Access Compliance Report

Public Rights-of-Way

(Pedestrian Signals)

Intersection ID: N/A	Main Street:	Cross Street: N/A	Location: N/A
ADA ID: 389AD6341F26	Signal Type: One Push Button-APS	Overall Compliance: No	Severity Score: BTN 1: N/A BTN 2: N/A No BTN: N/A
Codes/Mitigation Info/Possible Solution		Field Measurements/Component Compliance

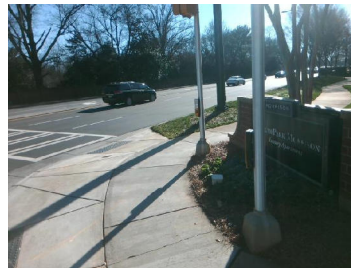
Surveyor Notes: SIGNAL POWERED, BUT CANT PUSH BUTTON

PROW/ADA: TMUTCD 4e.08, R404.2, R406.2, R209.1, TMUTCD 4e.10, MUTCD 4e.08, R104.2,

Possible Solutions: Replace Signal Push Button With APS Button on New Post. Remove & Relocate Sign.
